**ADDENDUM NO. 1****DATE:** November 7, 2025**PROJECT:** Water System Improvements
Water Treatment Plant Improvements and Watson Road Pump Station Replacement
Rock-Moore Public Water Authority
Sulphur Rock, Arkansas**BID DATE:** November 12, 2025, 2:00 PM

Rock-Moore Public Water Authority
Water System Improvements
Water Treatment Plant Improvements & Watson Road Pump Station Replacement

ADDENDUM NO. 1

SITE PLAN

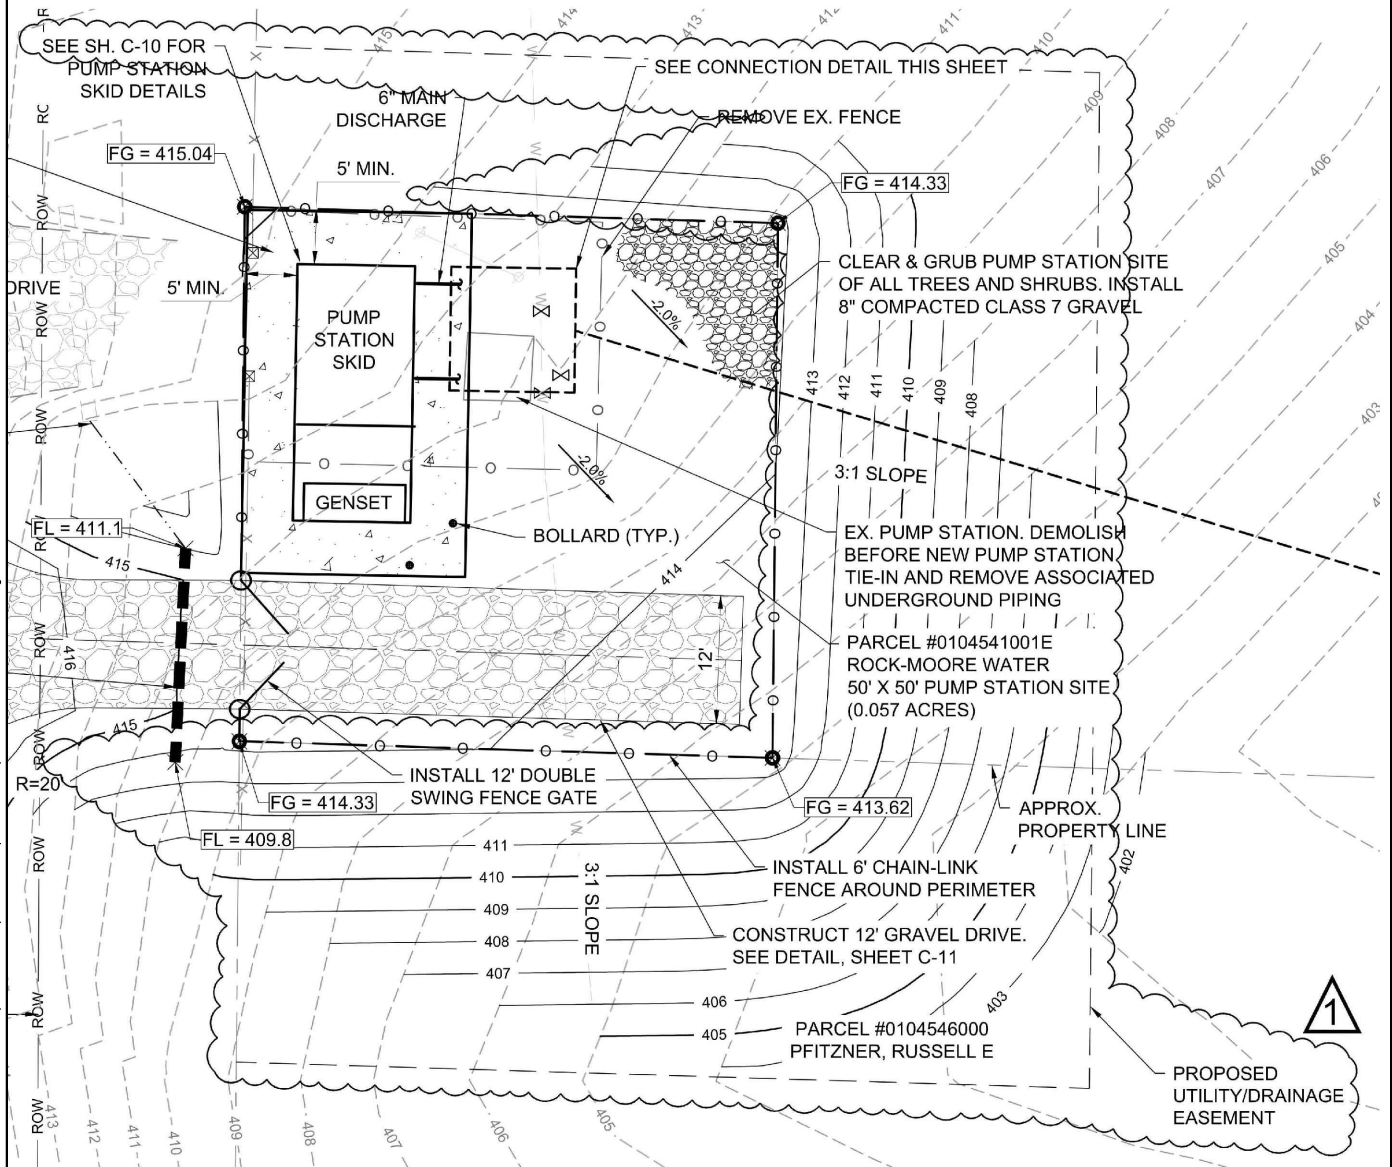
- A. Sheet C-9 – Site Plan
 - i. Modify this drawing as shown on the Addendum No. 1 – Site Plan, attached hereto:

7. Please reference drawing C-9 of subject project. The proposed singular grade line (elev 414) and point grades at the fence corner posts vary significantly from the existing grades. Is the intent to build up the site 1-9ft and taper off the grades around the perimeter? I do not find any indication of how these grades are to tie in. It appears that the property owners on three sides may need to give some slope easements to allow for the proposed changes or we would need to build some sort of retaining wall. Please clarify engineer's intent regarding the site grading of the Watson Road PS site. **The intent is to taper the grades around the perimeter with a 3:1 slope.**
